Value Engineering Study Report

*Georgia Department of Transportation
STP00-0000-00(421) – P.I. No. 0000421
SR 25 Spur from Cate Road along
CR 588/Canal Rd. to SR 99
Glynn County*

RE: Submittal of the final Value Engineering Report
STP00-0000-00(421) – P.I. No. 0000421
SR 25 Spur from Cate Road along CR 588/Canal Road to SR 99
Glynn County

ALTERNATIVE NO.:
RD-2

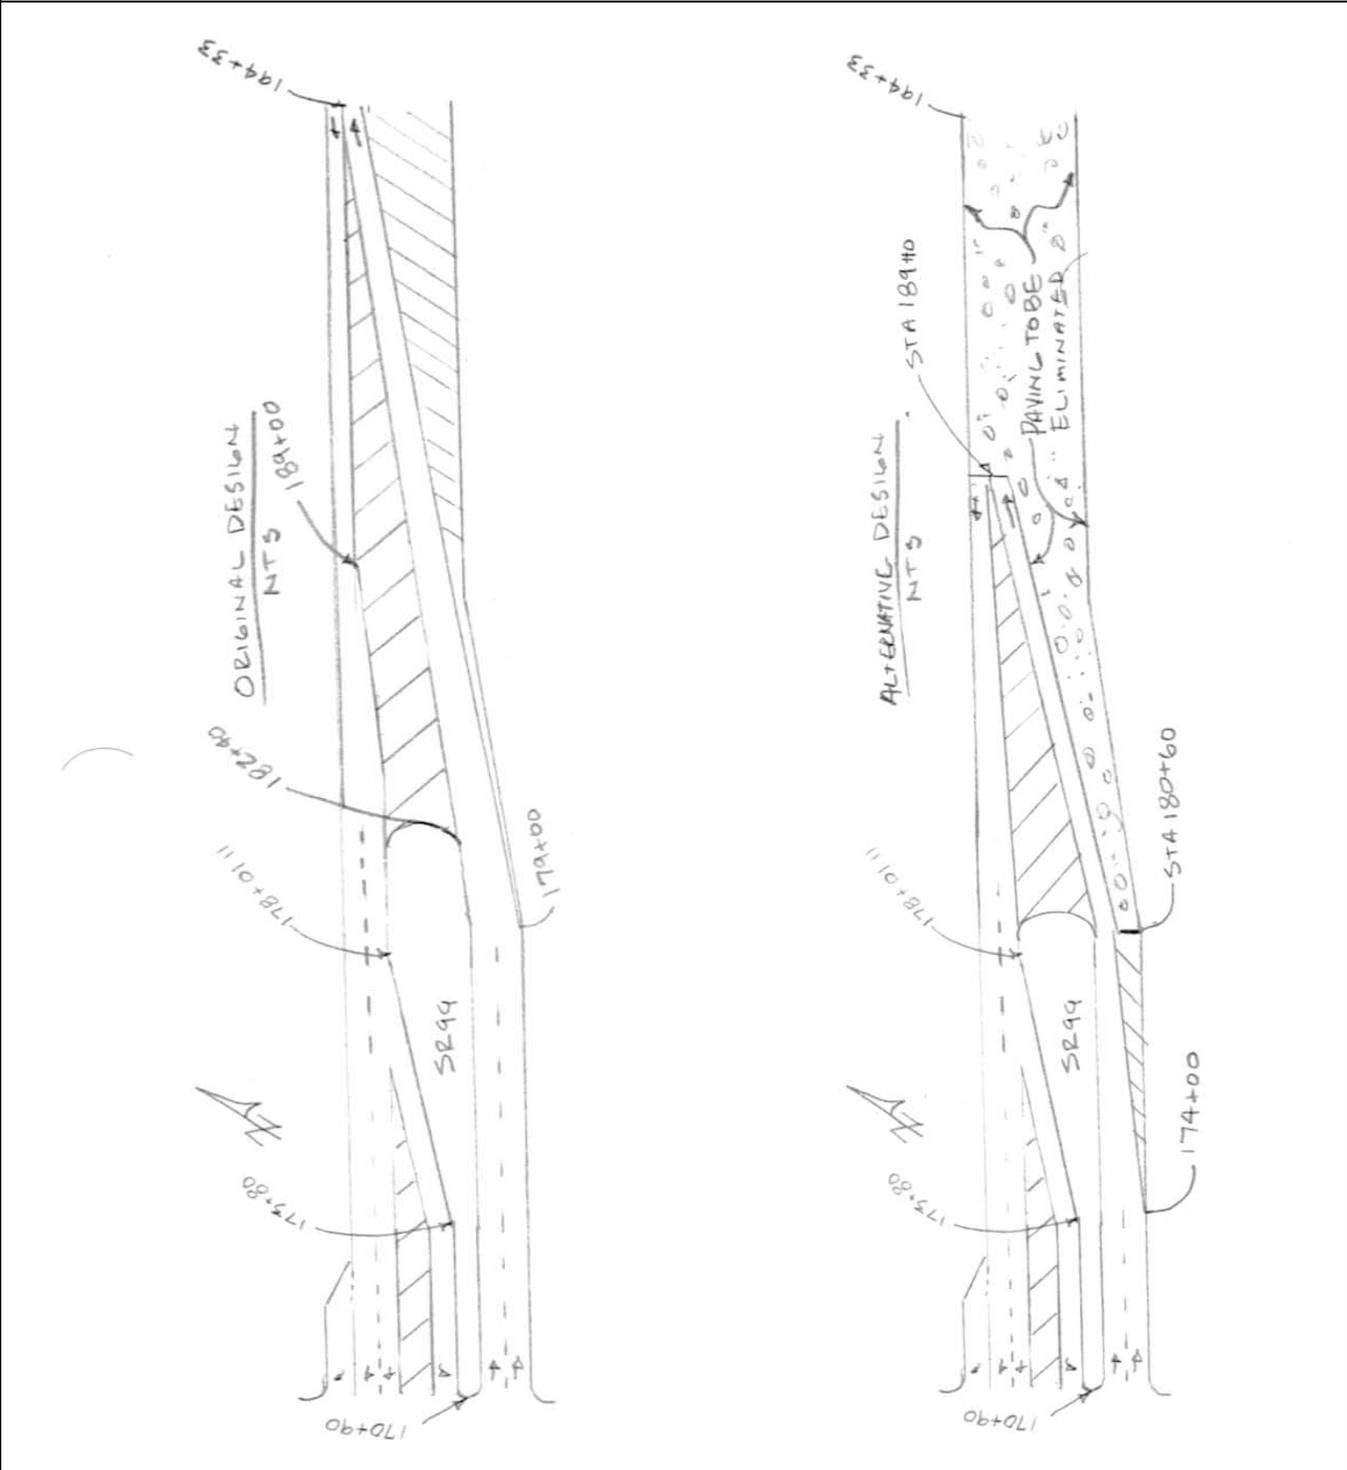
The original design proposes 4,433 lf of improvements along SR-99.

The alternative design proposes to reducing the improvements as follows:

Reduced full depth paving: Station ~189+10 to Station ~194+33.3=> 525 LF

Station ~180+60 to Station ~189+10=> 850 LF

The area proposed for elimination is not necessary for the implementation of the current project and elimination will not adversely affect its operation. While the additional pavement proposed might simplify the future widening to the south, this is a long range project. The additional pavement will likely sit for an extended period without any direct traffic and may be subject to deterioration. The additional pavement may also create a large area of unused pavement that may be attractive to illegal parking and may potentially create a safety issue.

ALTERNATIVE NO.:
RD-5

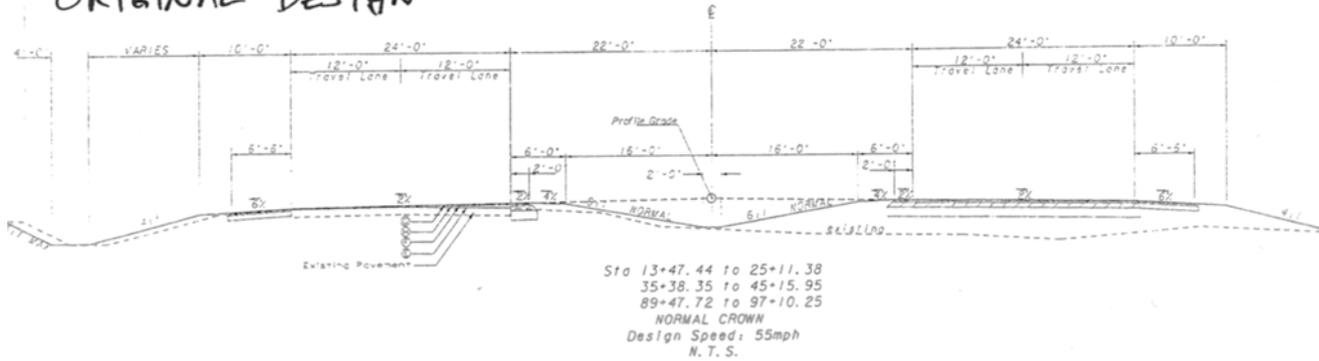
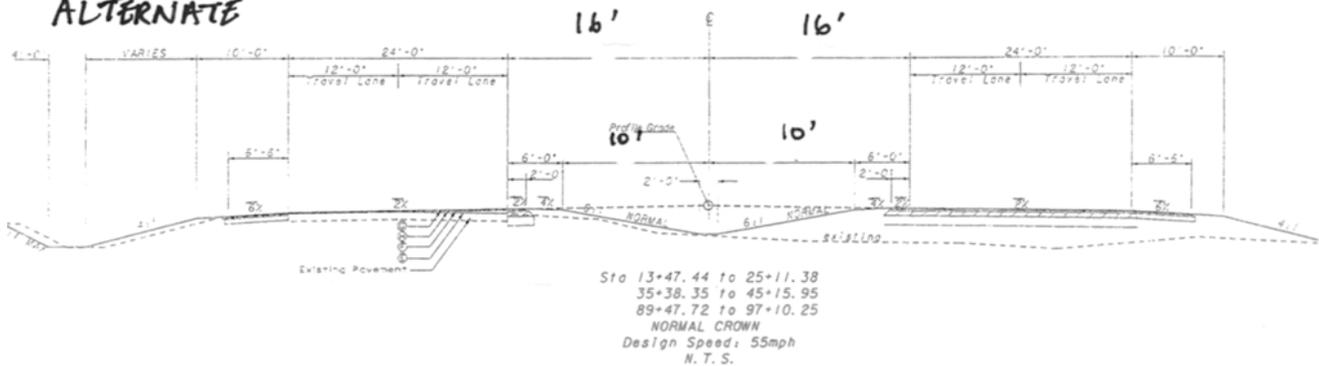
The original design proposes constructing a 44' grassed depressed median throughout the project.

The alternative design proposes using a 32' grassed depressed median in-lieu of the originally designed 44' grassed depressed median.

The alternative proposes narrowing the median from 44' to 32' throughout the project. A reduction of 12' in the median width will not reduce the functional requirements of the clear zone, and should not have an adverse impact on vehicular traffic.

NARROW MEDIAN TO 32' NOMINAL WIDTH

ALTERNATIVE NO.:
RD-6

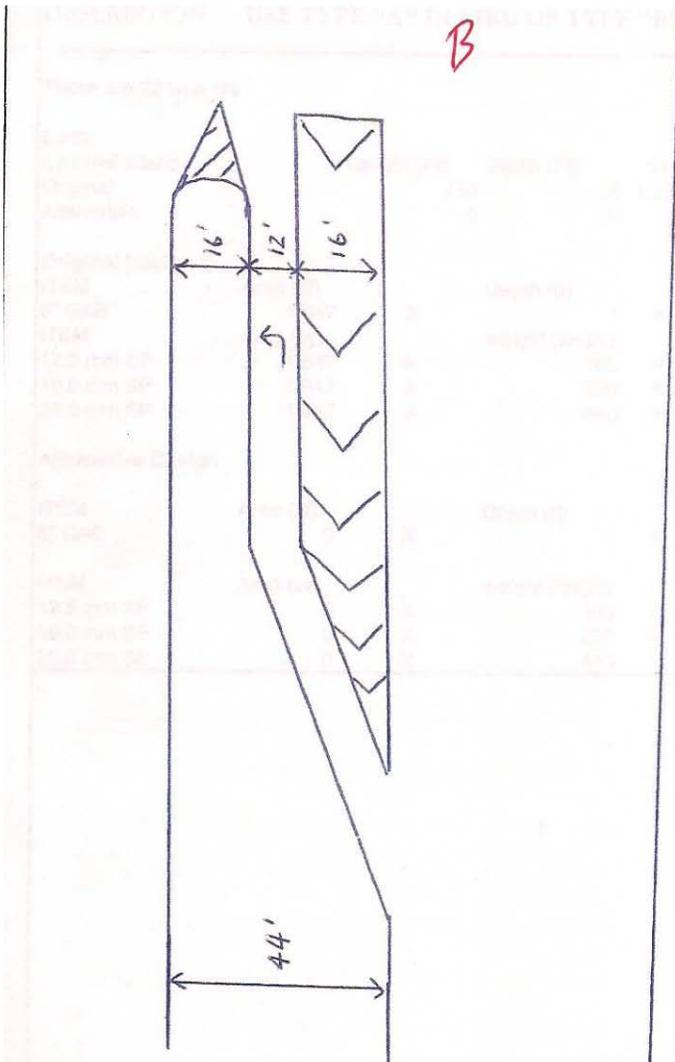
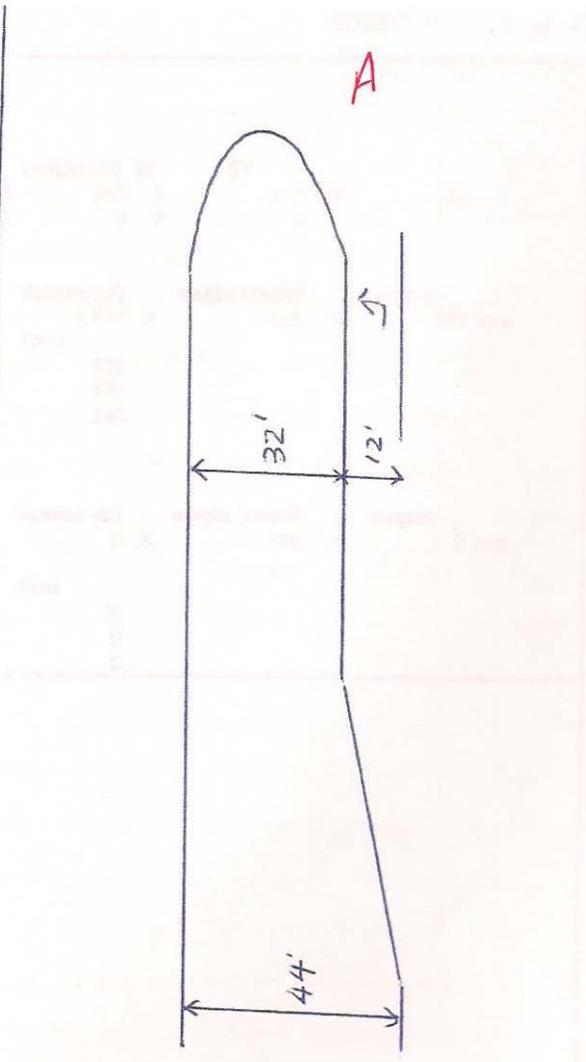
The original design proposes to replace the existing Cate Road Type "A" median crossover with a Type "B" median crossover and to construct all Type "B" median crossovers with eyebrows at all intersections.

The alternative design would be to retain the existing Cate Road Type "A" median crossover and to construct all Type "A" median crossovers for the project.

The GDOT Standards state that Type "B" median crossovers are the preferred type of median crossover; but that Type "A" median crossovers can be used as the situation may allow. Based on the Traffic Study information, using the Type "A" median crossovers should be acceptable. The roadway has little of no commercial development, flat terrain and relatively low truck traffic volumes (4 %) so sight obstructions at the intersections should be minimal.

Also, using the Type "A" median crossover, the majority of the traffic should be able to make "U" turns without requiring "eyebrows".

ALTERNATIVE NO.:
RD-8

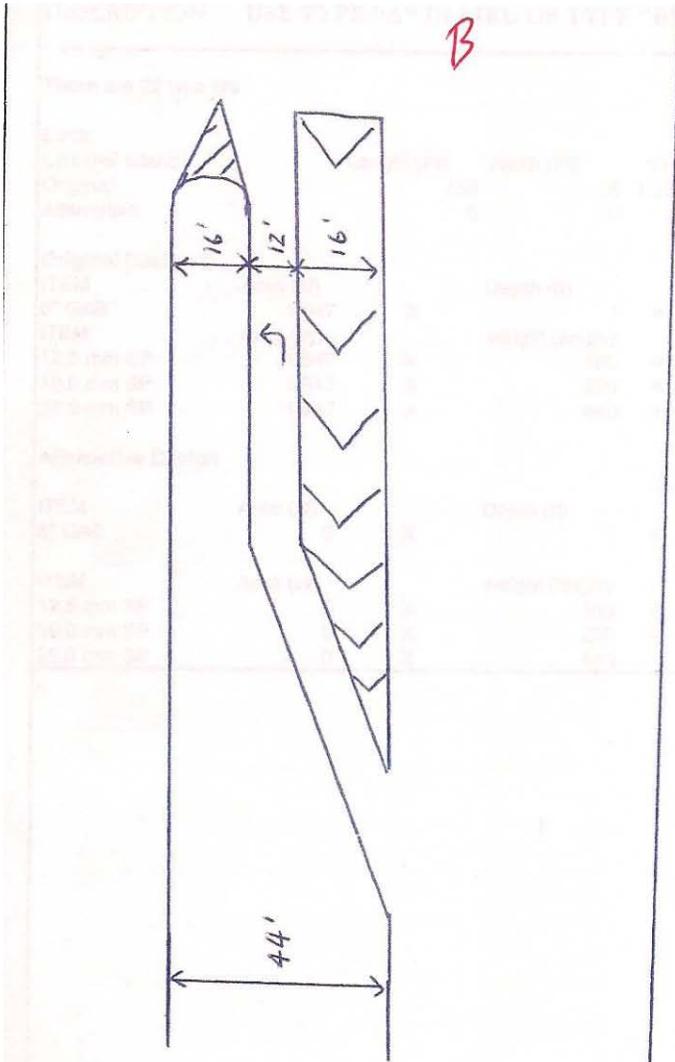
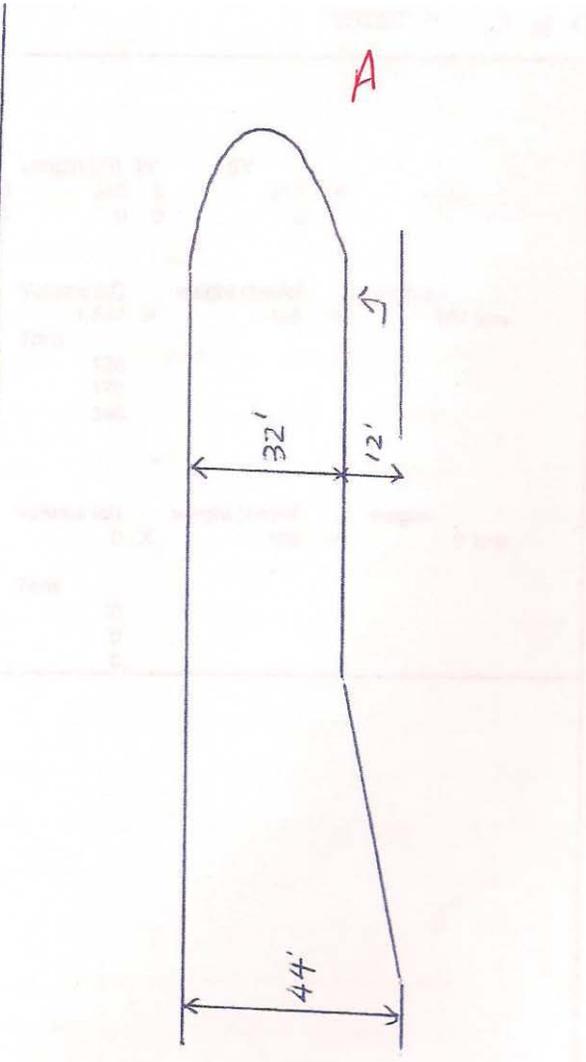
The original design proposes to replace the existing Type "A" median cross over with a Type "B" median cross over and to construct a type "B" median crossover with an eyebrow at the existing northern portion of the intersection to allow southbound traffic to make a "U" turn.

The alternative design would be to maintain the existing intersection alignment and retain the existing intersection, as is, including the existing Type "A" median cross over, and the existing southbound right turn lane. New construction would only be for a "U" turn lane for the southbound lane utilizing a Type "A" median crossover in-lieu of a type B.

The GDOT Standards state that Type "B" median crossovers are the preferred type of median crossover; but that Type "A" median crossovers can be used as the situation may allow. Based on the Traffic Study information, using the Type "A" median crossovers should be acceptable. The roadway has little of no commercial development, flat terrain and relatively low truck traffic volumes (4 %) so sight obstructions at the intersections should be minimal.

Also, using the Type "A" median crossover, the majority of the traffic should be able to make "U" turns without requiring "eyebrows"

DESCRIPTION: **Use 11' inside, 12' outside travel lanes throughout project** SHEET NO.: **2 of 4**

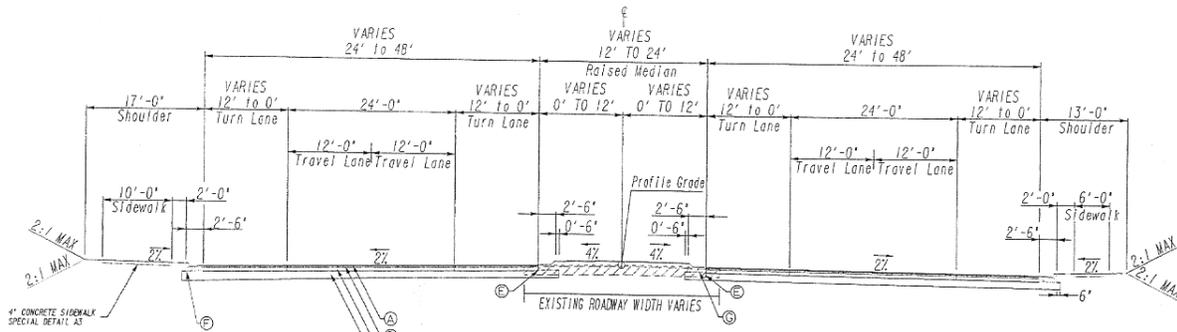
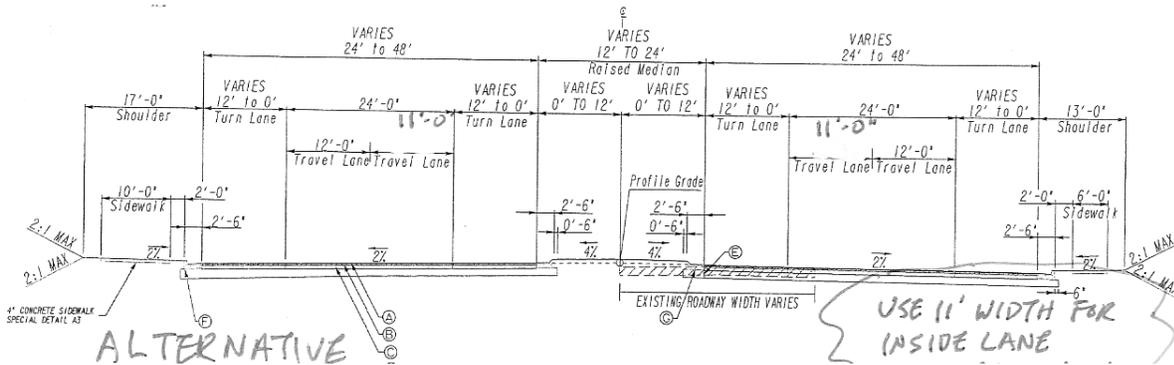
The alternative proposes narrowing the inside lanes in both directions to a 11' width, while constructing the outside lanes at the originally proposed 12' width. The resulting savings below are accounted by the savings of 1' of full depth pavement being eliminated in both directions throughout the project. The design speed for the proposed project is 55 mph; however truck volume is relatively low at 4%. Constructing the outside lane at 12' would allow extra width for the 4% truck traffic. Although the roadway is a State Route it is classified as an Urban Collector and not an Arterial.

ALTERNATIVE NO.:
RD-13

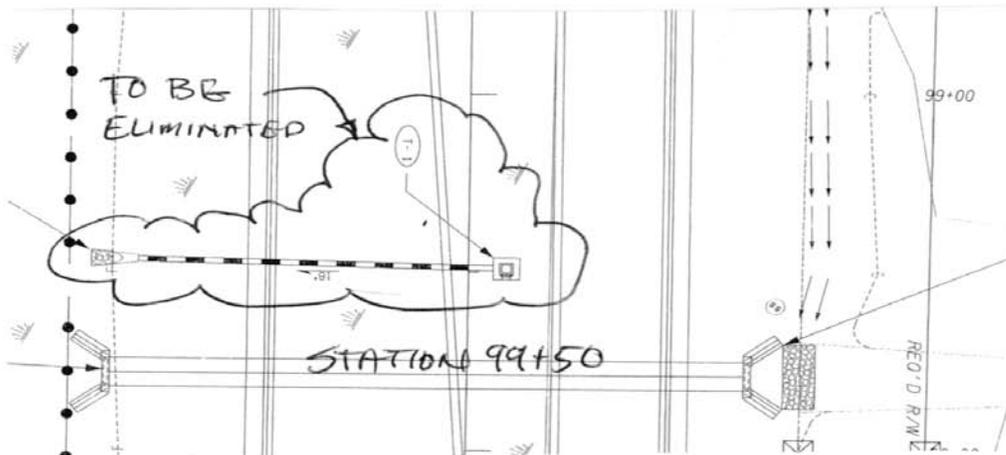
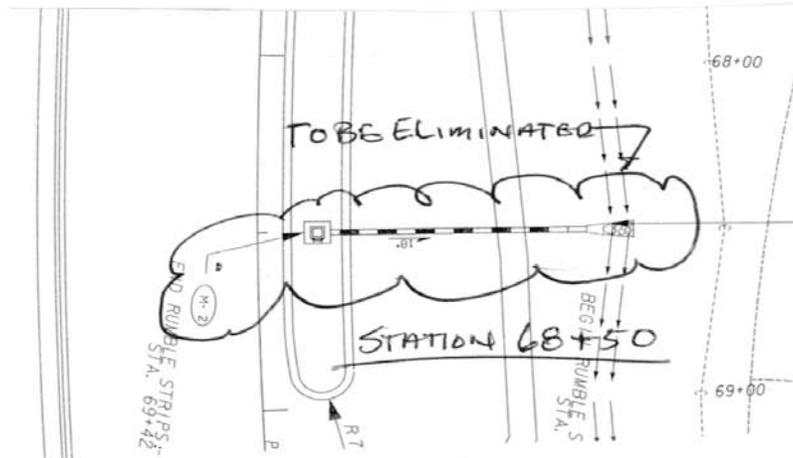
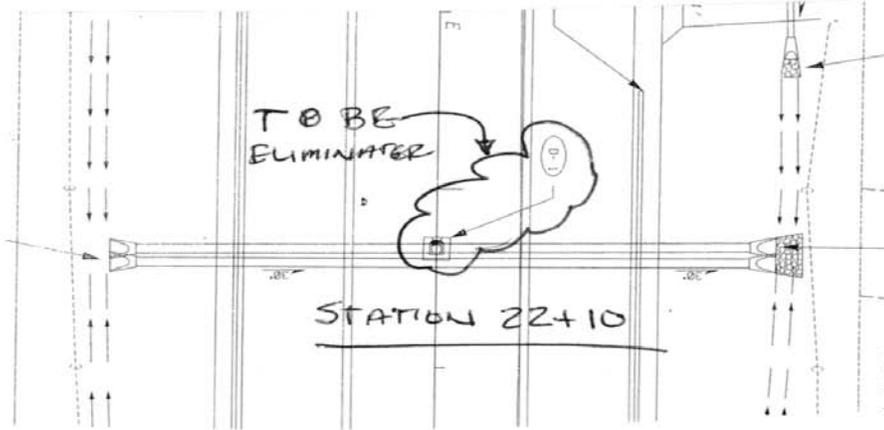
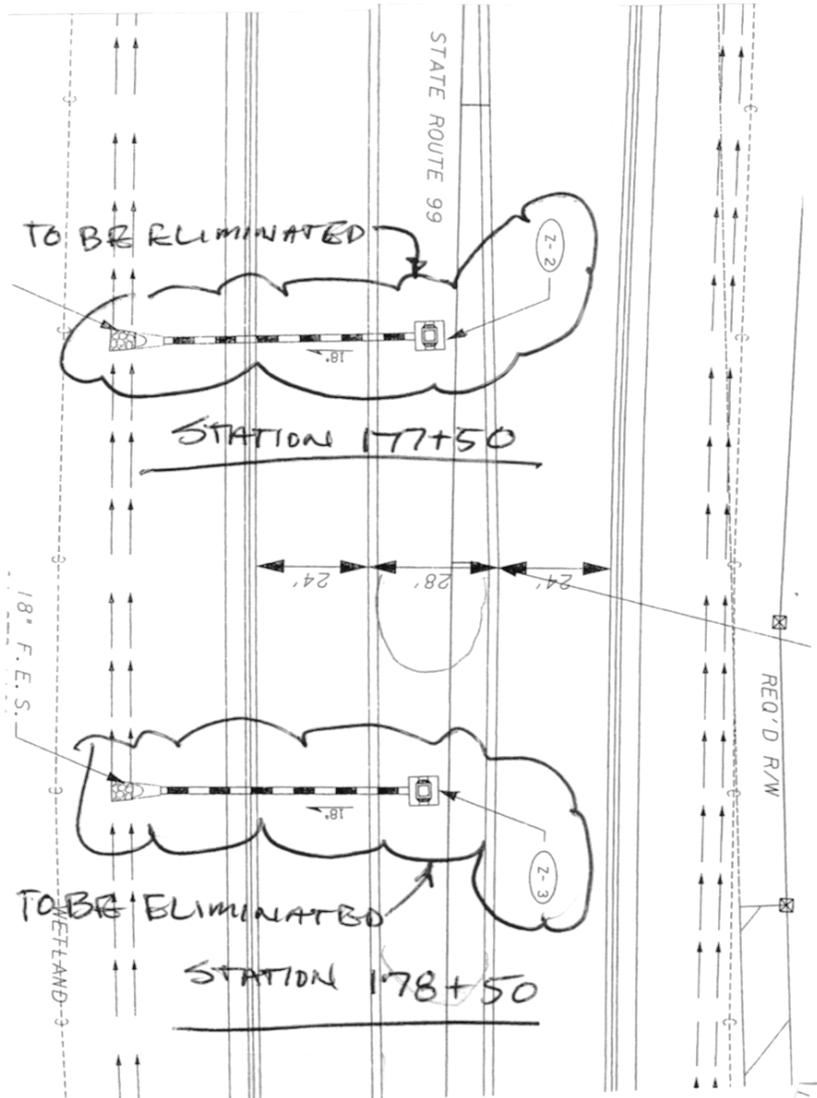
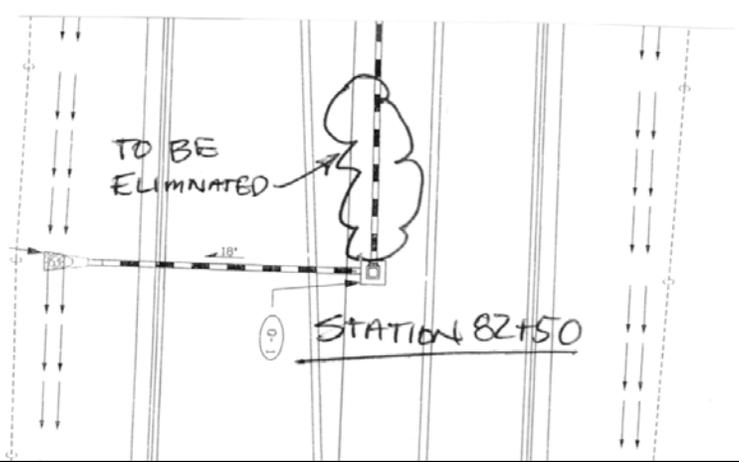
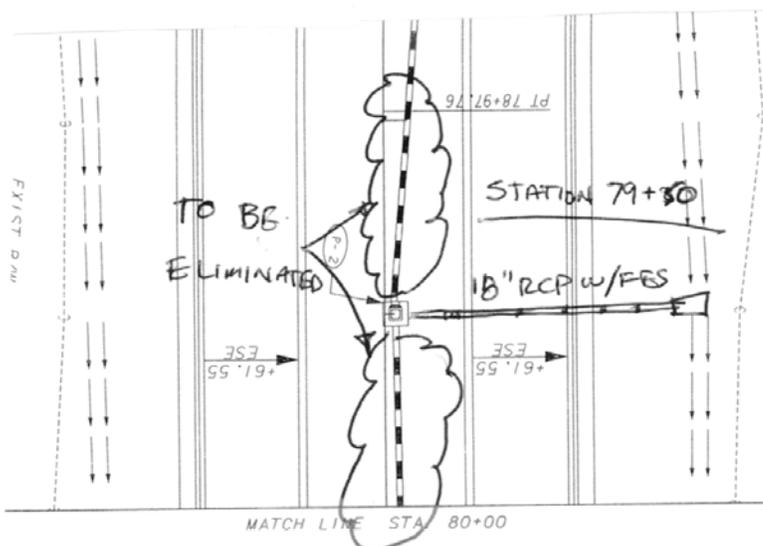
COST SUMMARY	INITIAL COST	PRESENT WORTH RECURRING COSTS	PRESENT WORTH LIFE-CYCLE COST
ORIGINAL DESIGN	\$ 103,857	\$ 0	\$ 103,857
ALTERNATIVE	\$ 41,250	\$ 0	\$ 41,250
SAVINGS	\$ 62,607	\$ 0	\$ 62,607
